ARKANSAS NUCLEAR ONE - UNIT 1

Amendment No. 6
License No. DPR-51

ATTACHMENT TO LICENSE AMENDMENT NO. 6

CHANGE NO. 6 TO THE TECHNICAL SPECIFICATIONS

ARKANSAS POWER & LIGHT CO. ARKANSAS NUCLEAR ONE-UNIT 1	CONTROL ROD GROUP WITHDRAWAL LIMITS FOR 4 PUMP OPERATION	FIG. NO. 3.5.2-1A
---	---	----------------------

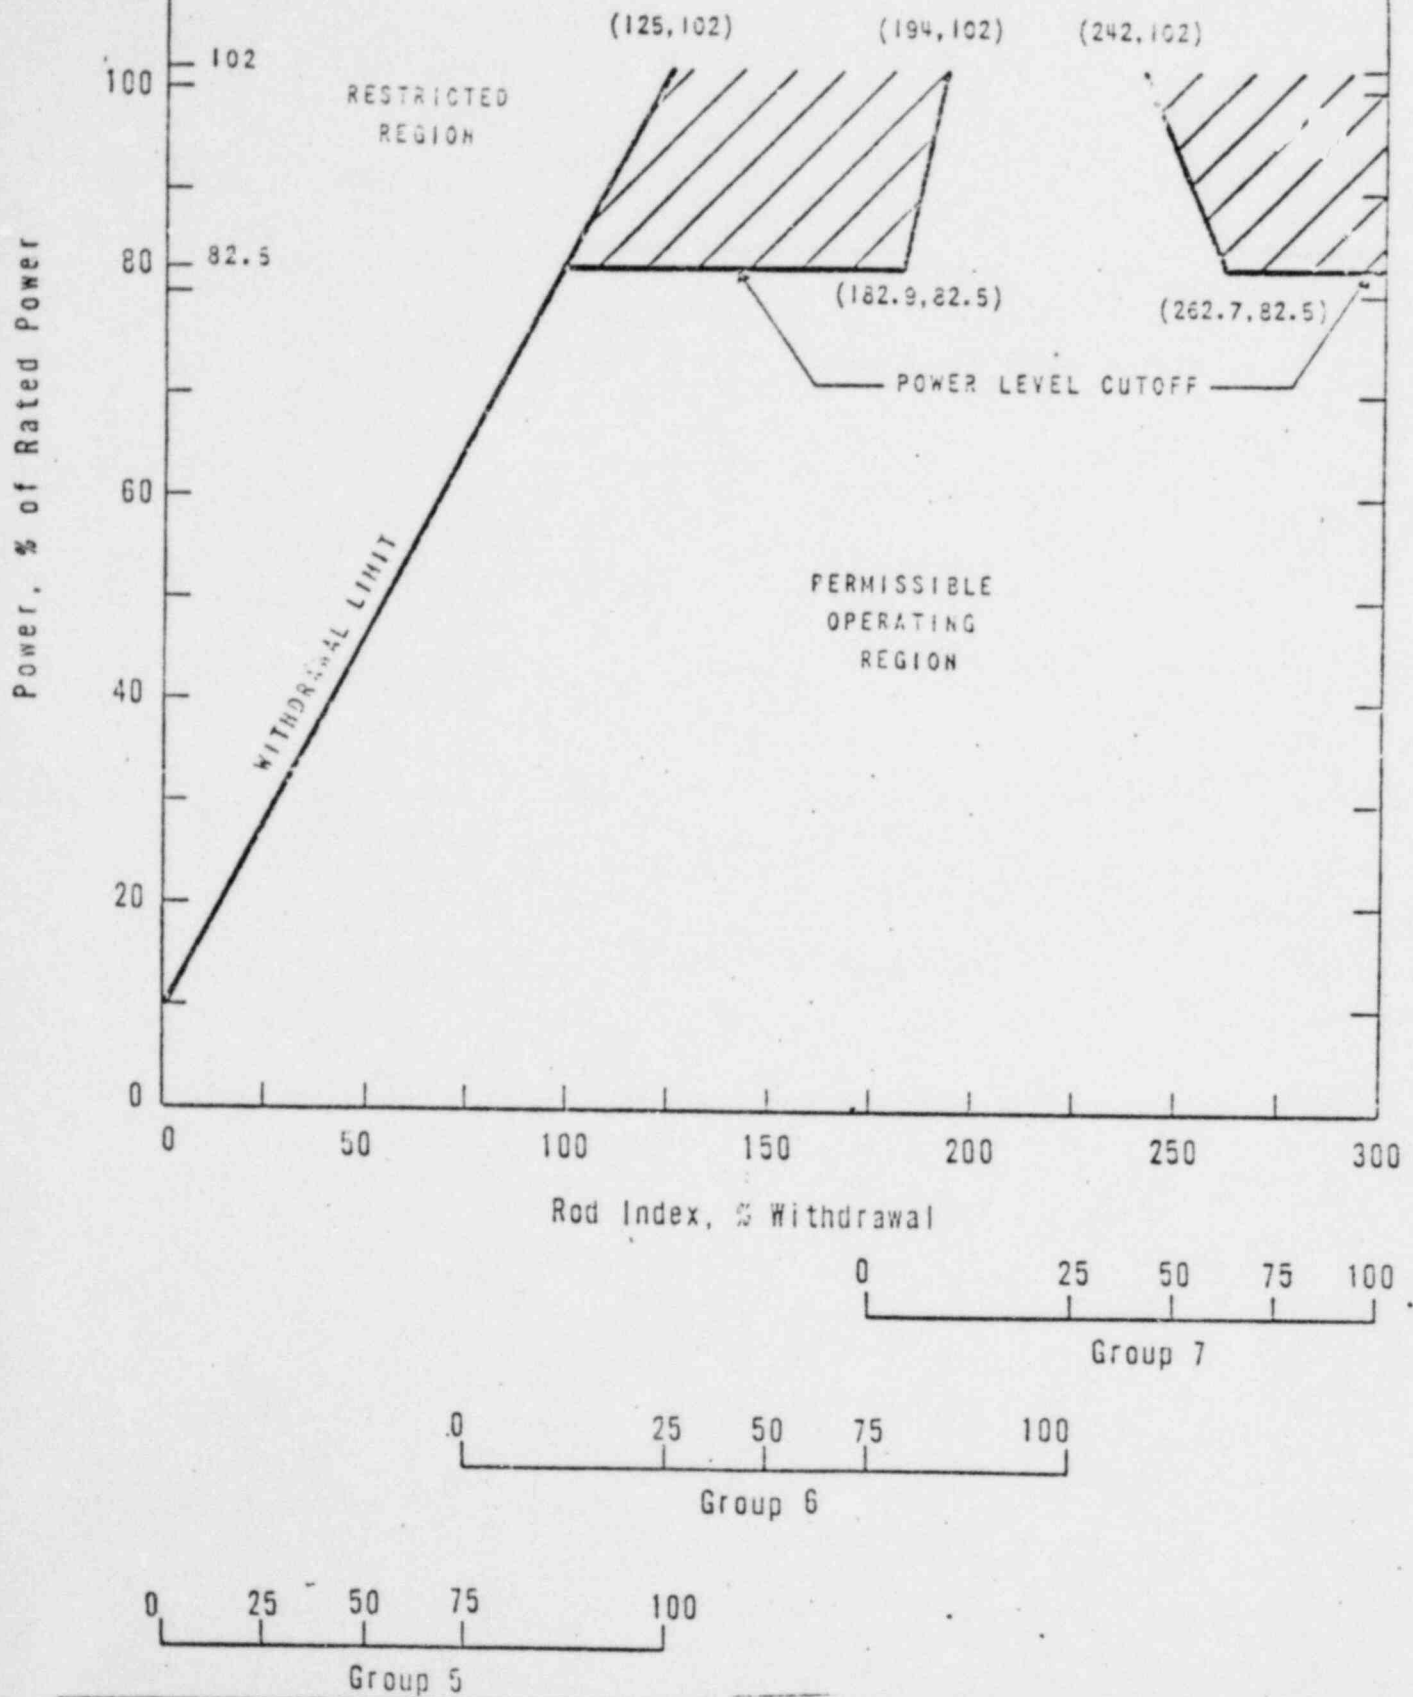
2. Restrictions on withdrawal (hashed areas) are modified after the control rod interchange (See Fig. 3.5.2-1B)

ARKANSAS POWER & LIGHT CO. ARKANSAS NUCLEAR ONE-UNIT 1	CONTROL ROD GROUP WITHDRAWAL LIMITS FOR 4 PUMP OPERATION	FIG. NO. 3.5.2-1B
---	---	----------------------

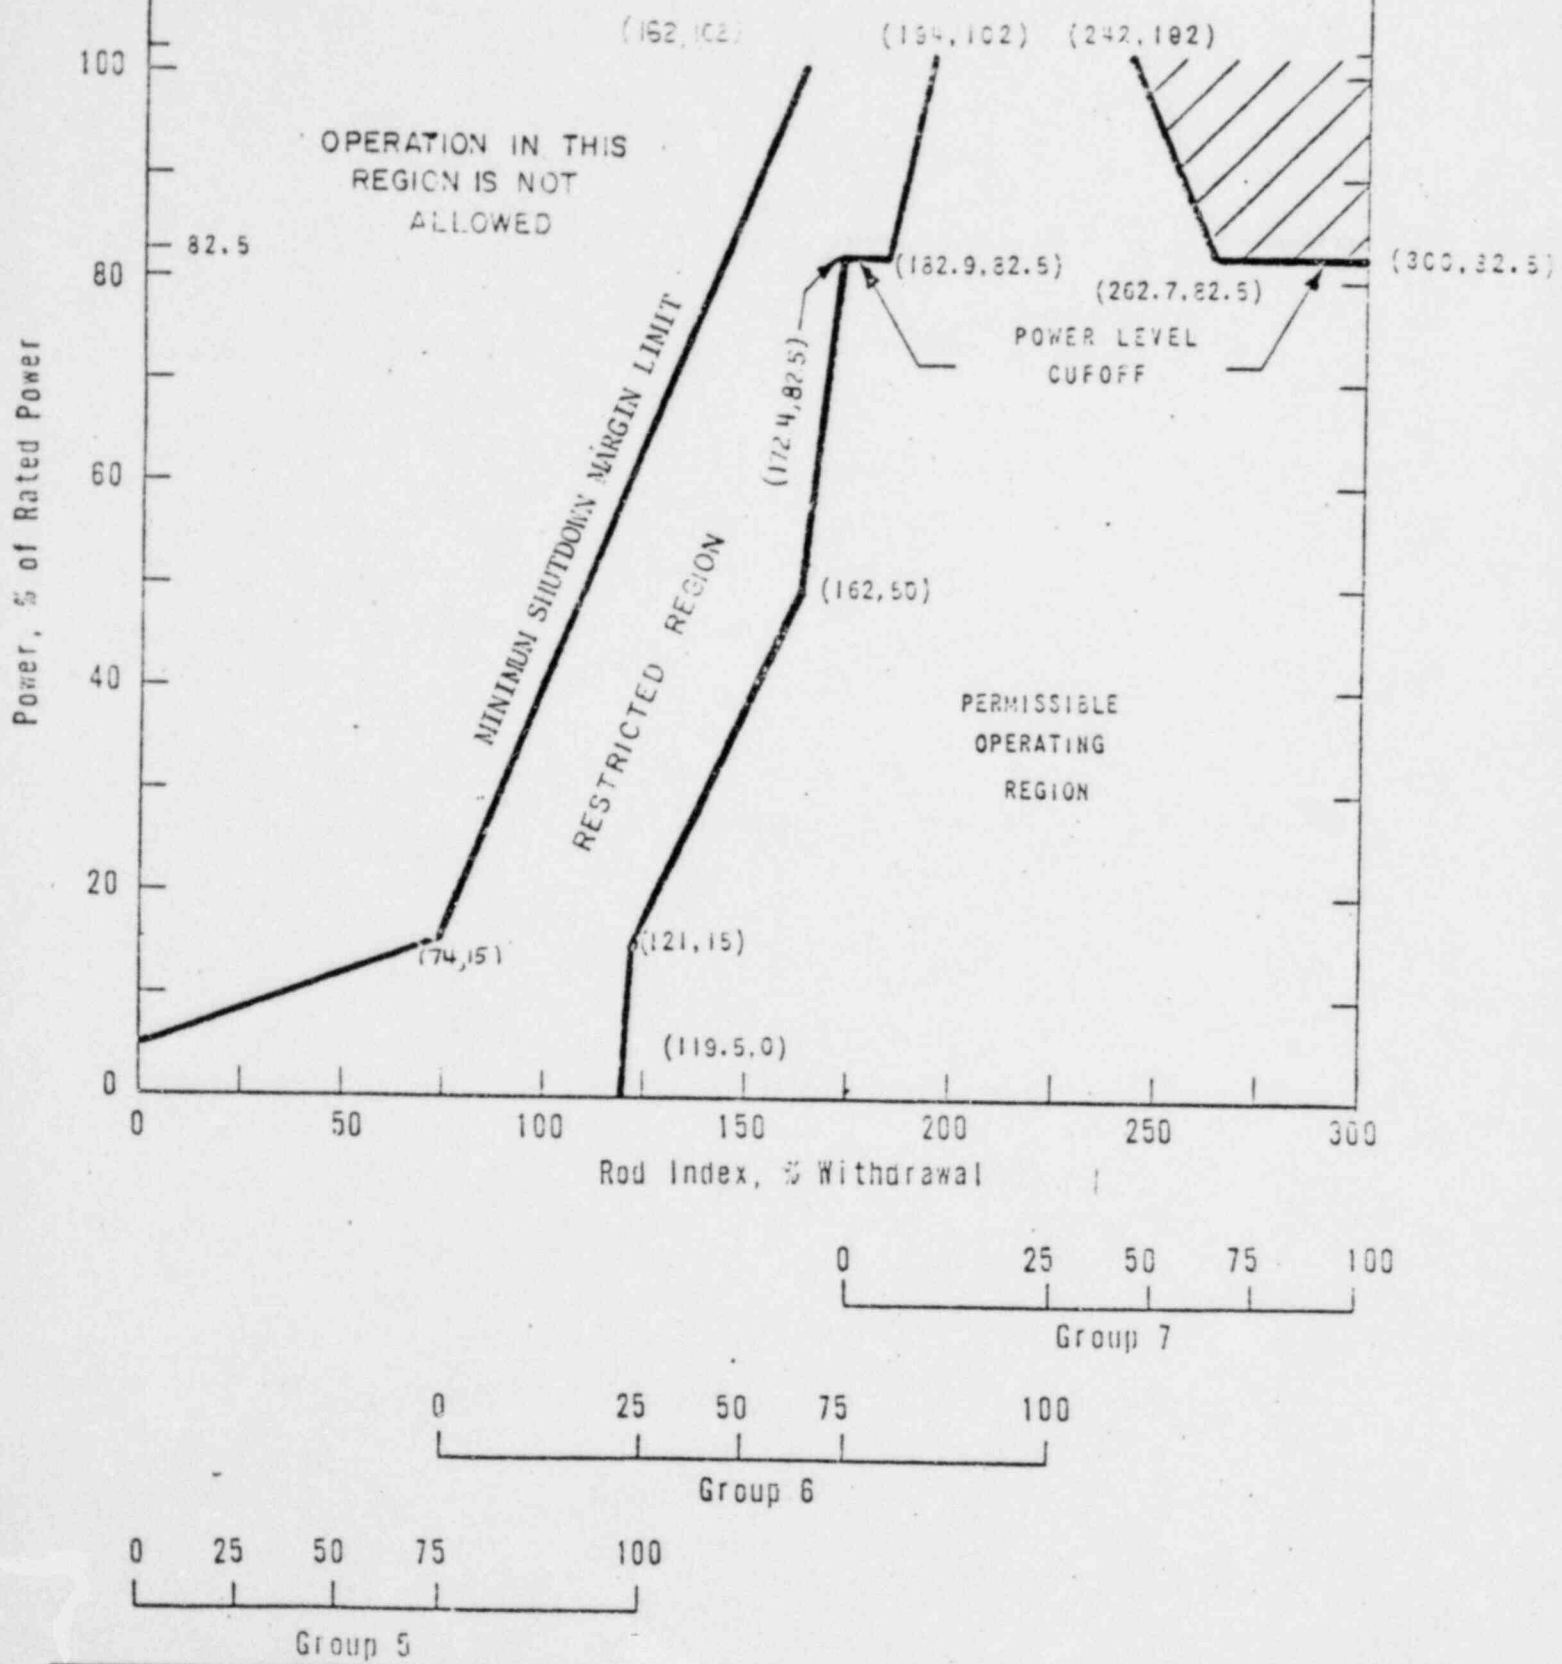
1. Rod Index is the percentage sum of the withdrawal of the operating groups
2. The additional restrictions on withdrawal (hatched areas) are in effect after the control rod interchange. The restrictions on withdrawal are further modified after 435 full power days of operation (See Figure 3.5.2-1C)

FIG. NO.
3.5.2-1C

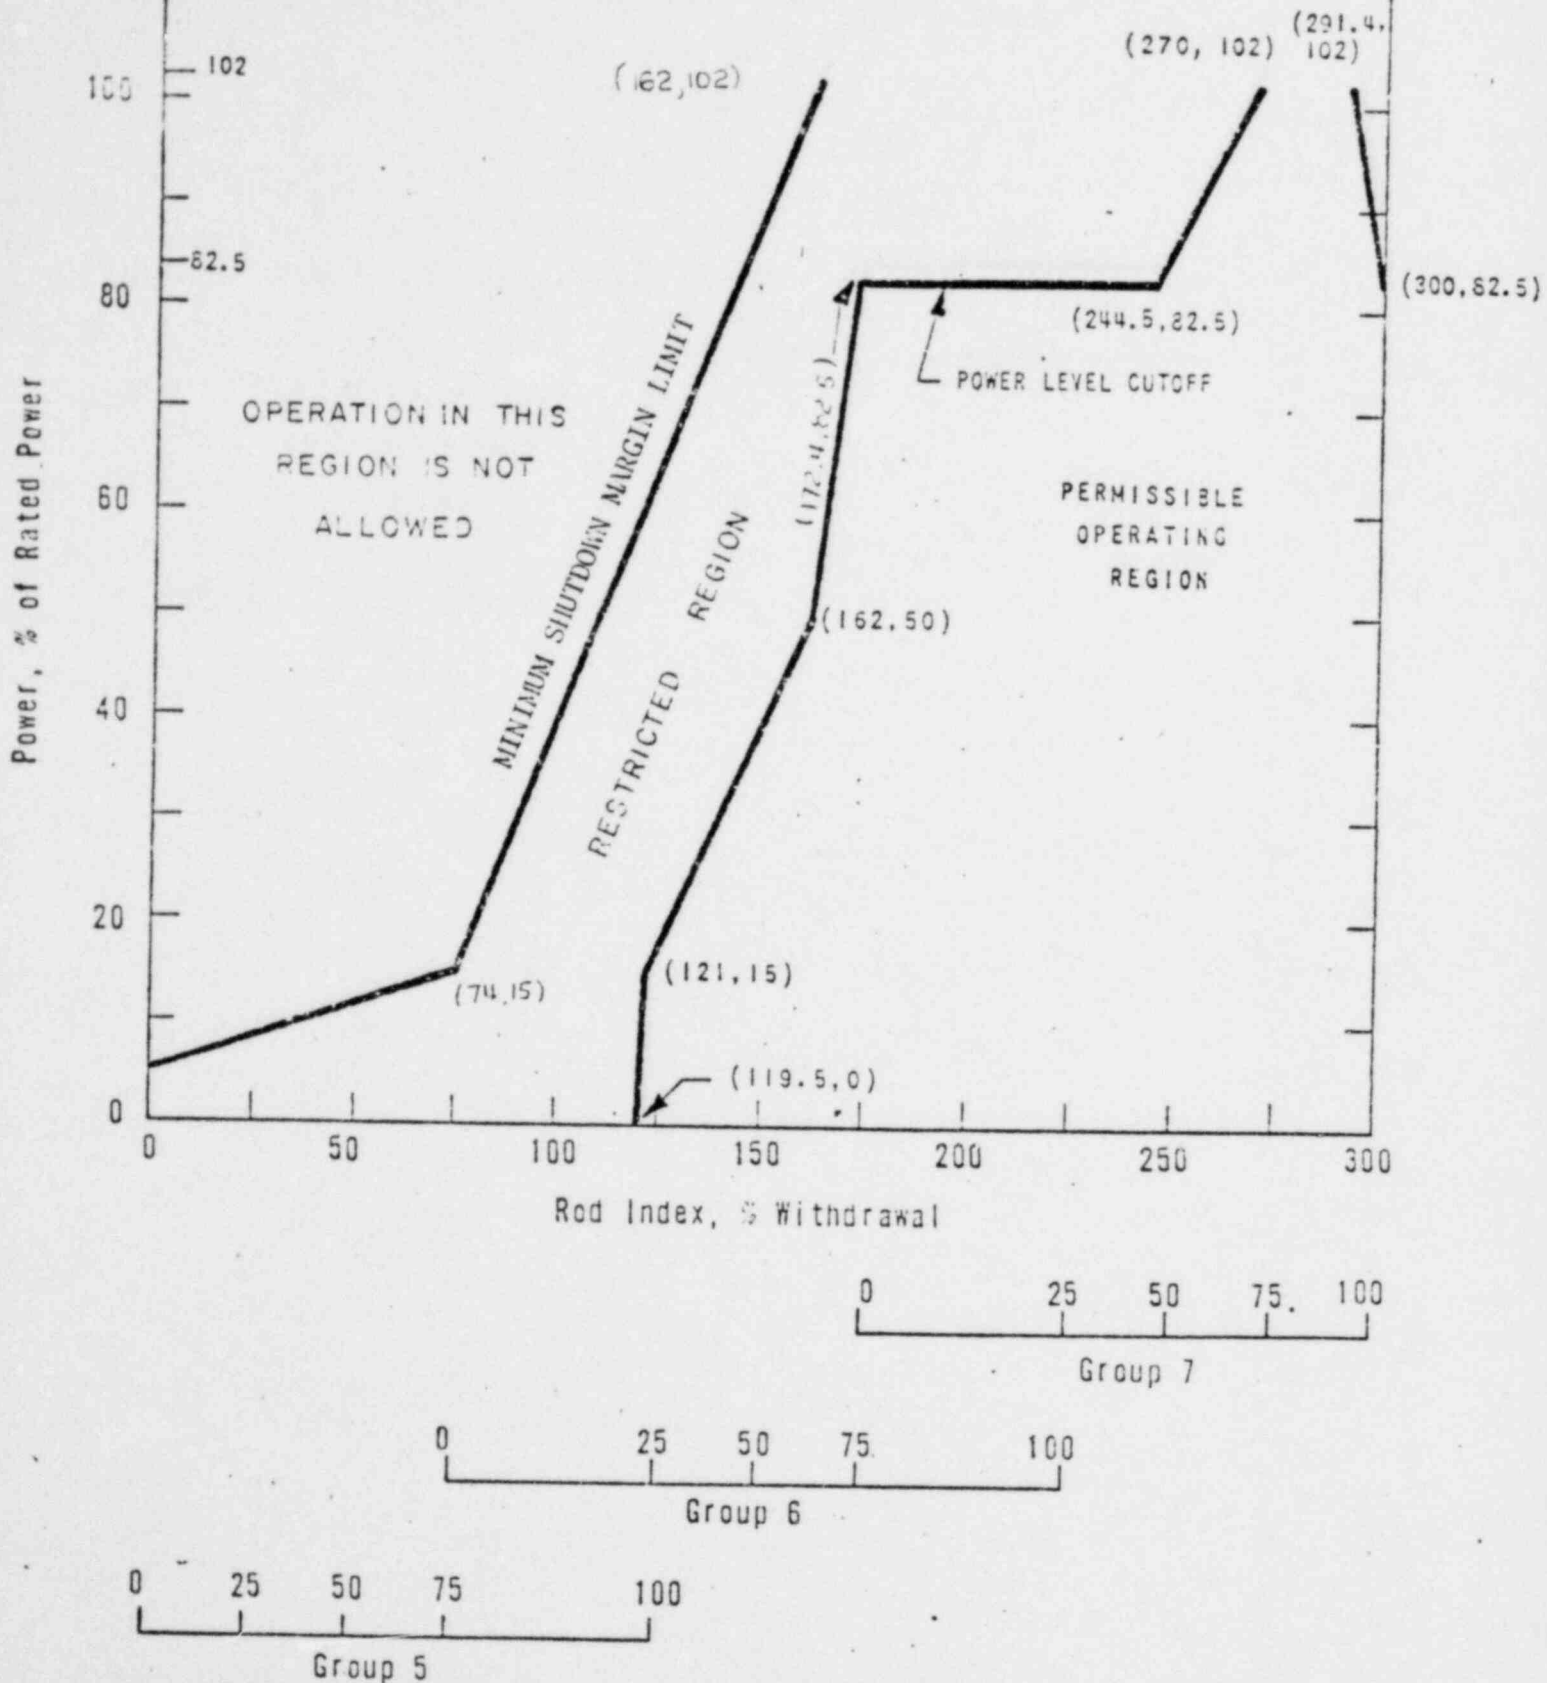
- The additional restrictions on withdrawal are in effect after 435 full power days of operation.

ARKANSAS POWER & LIGHT CO. ARKANSAS NUCLEAR ONE-UNIT 1	CONTROL ROD GROUP WITHDRAWAL LIMITS FOR 3 AND 2 PUMP OPERATION	FIG. NO. 3.5.2-2
---	---	---------------------

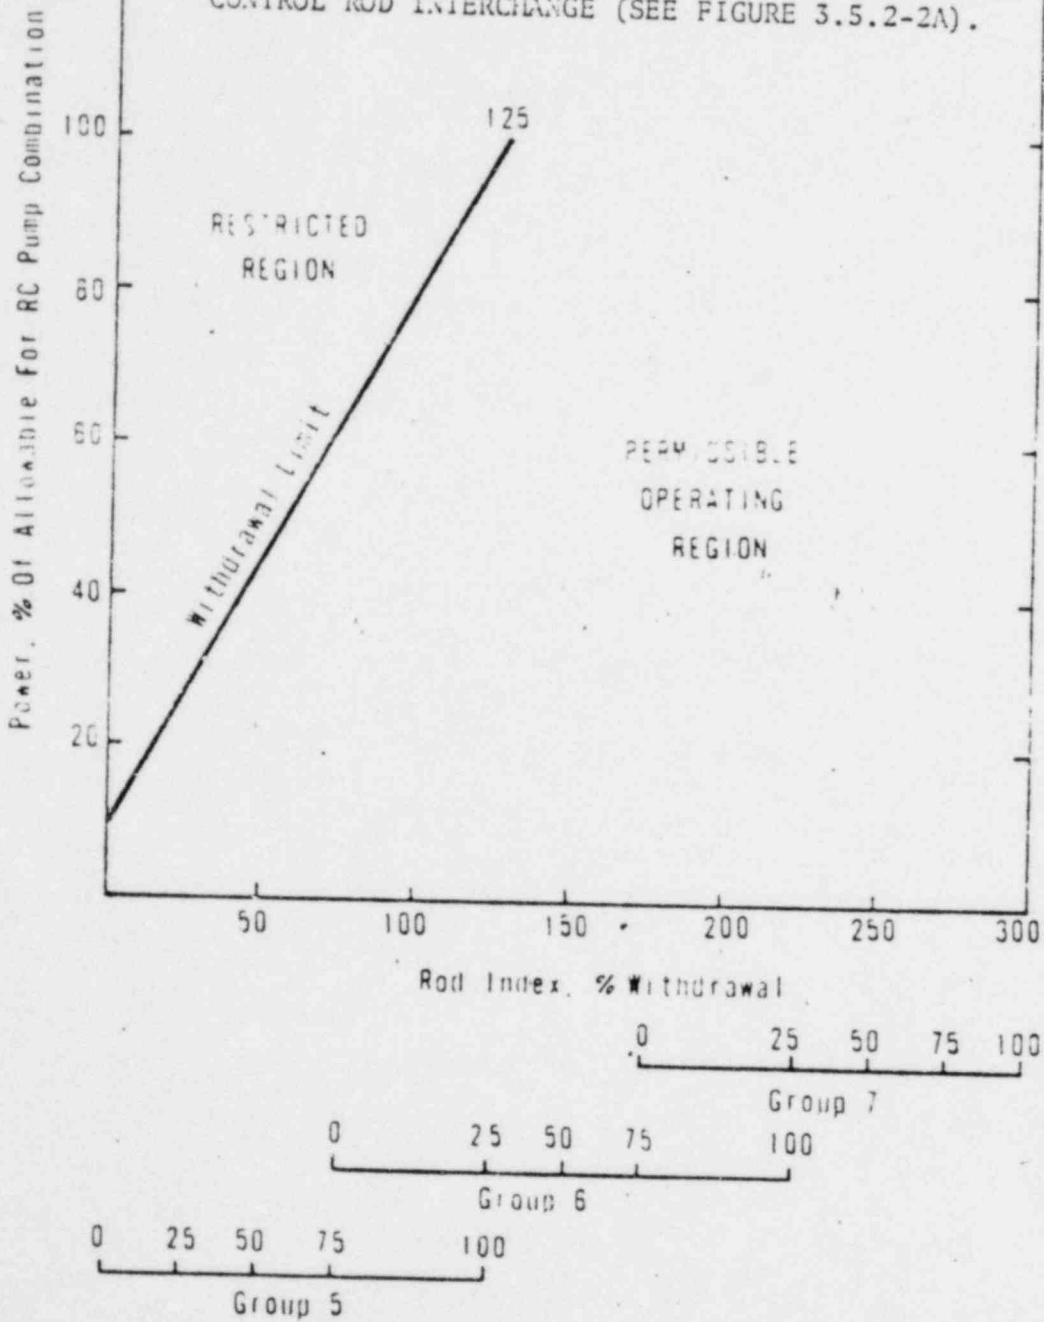
2. ADDITIONAL RESTRICTIONS ARE REQUIRED FOLLOWING CONTROL ROD INTERCHANGE (SEE FIGURE 3.5.2-2A).

ARKANSAS POWER & LIGHT CO. ARKANSAS NUCLEAR ONE-UNIT 1	CONTROL ROD GROUP WITHDRAWAL LIMITS FOR 3 AND 2 PUMP OPERATION	FIG. NO. 3.5.2-2A
---	---	----------------------

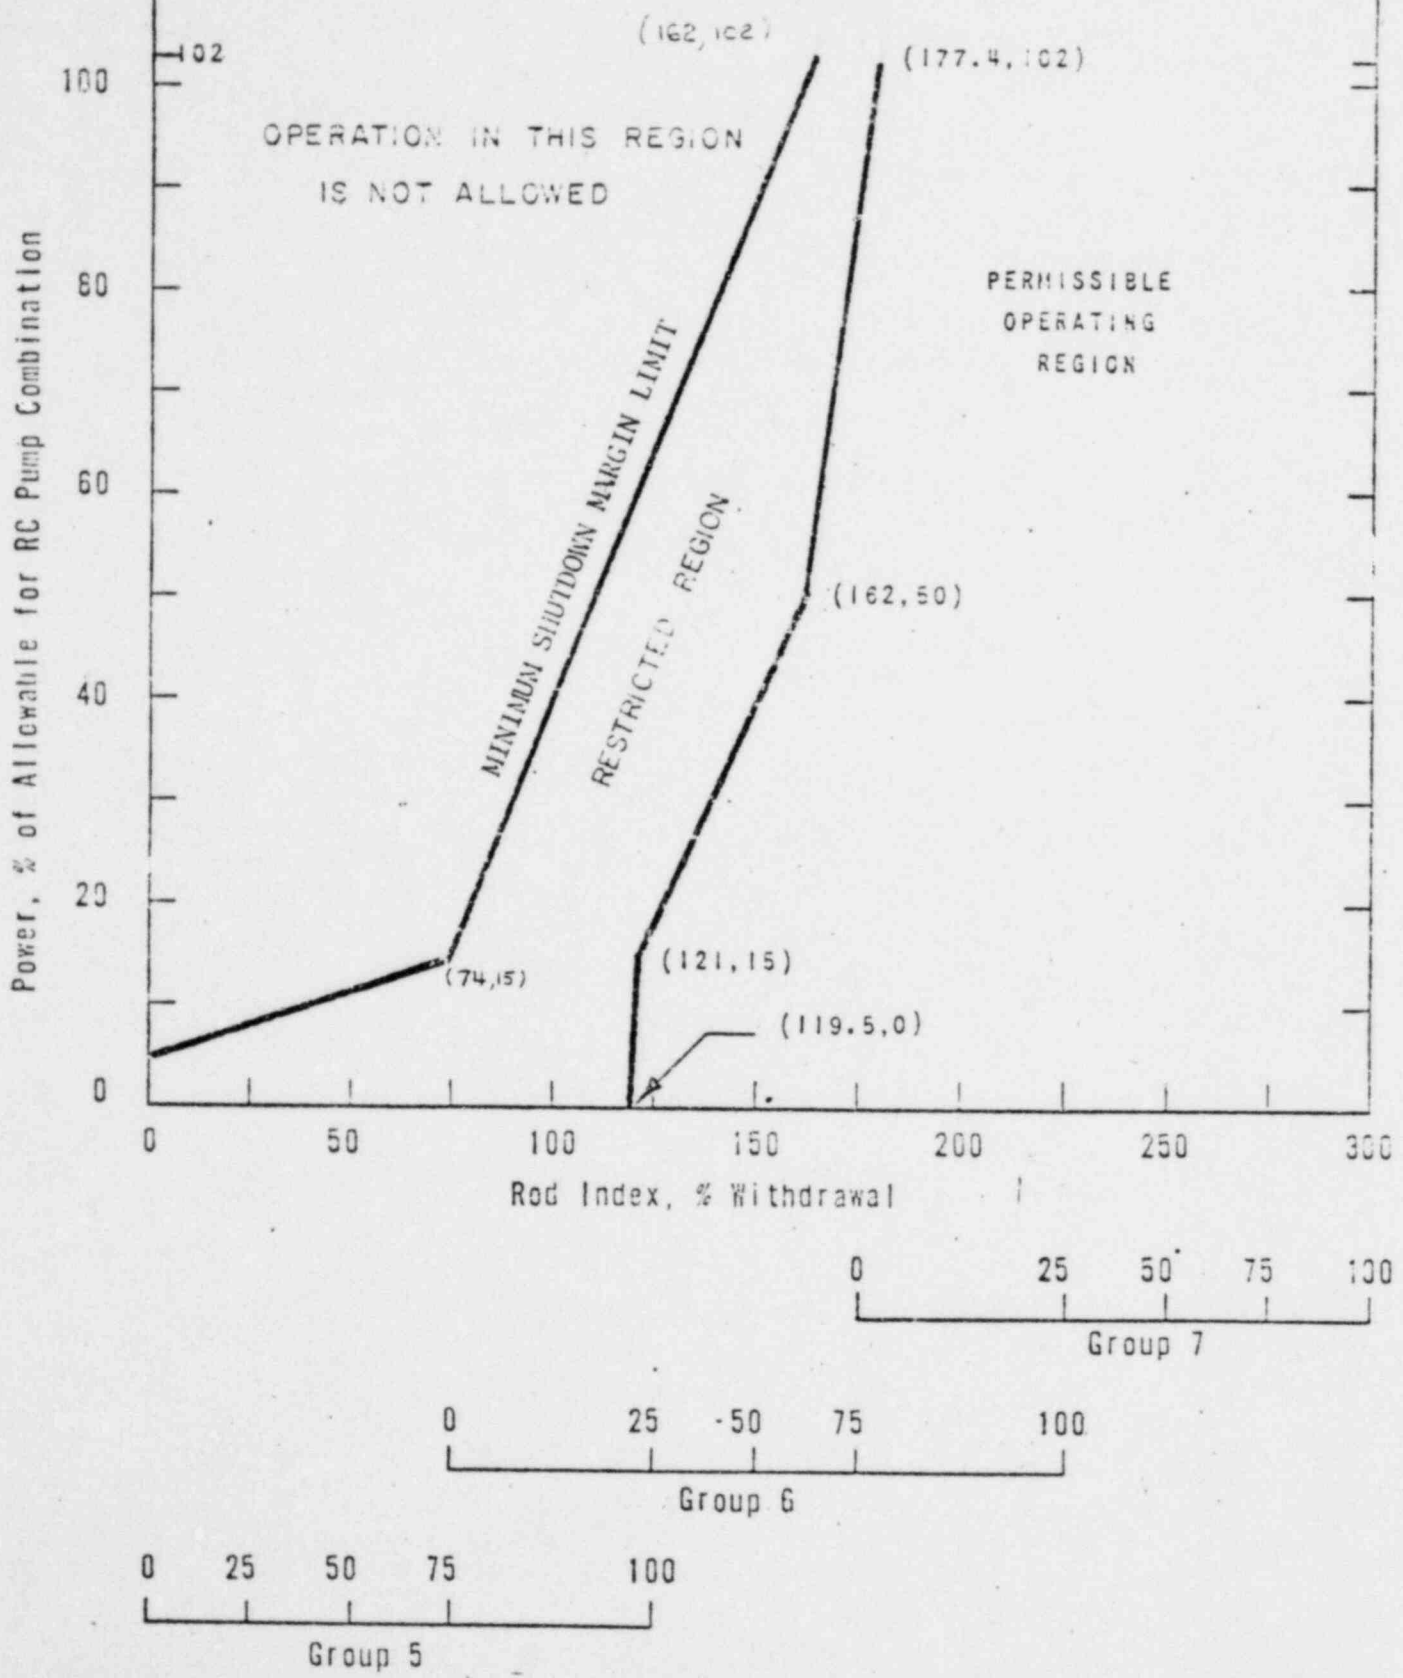
1. ROD INDEX IS THE PERCENTAGE SUM OF THE WITHDRAWAL OF THE OPERATING GROUPS.
2. THESE RESTRICTIONS APPLY FOLLOWING CONTROL ROD INTERCHANGE.
